Willow Park

Town of Fairhaven ADA Transition Plan

August 2024

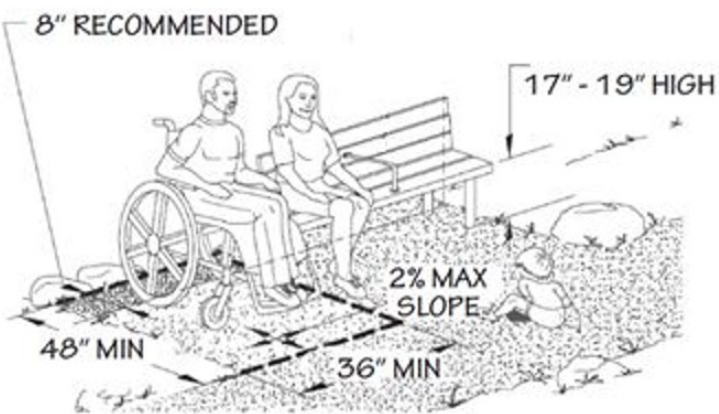
- Recommend providing a 36" min. by 48" min. stable, firm and slip-resistant surface adjacent to at least one of the existing benches in each unique program area in the park in a manner that is substantially similar to what is shown in Figure 1.

Figure 1 shows a stable, firm and slip-resistant surface adjacent to a bench positioned to allow a person in a wheeled mobility device and a person sitting on the bench to have their shoulders aligned:
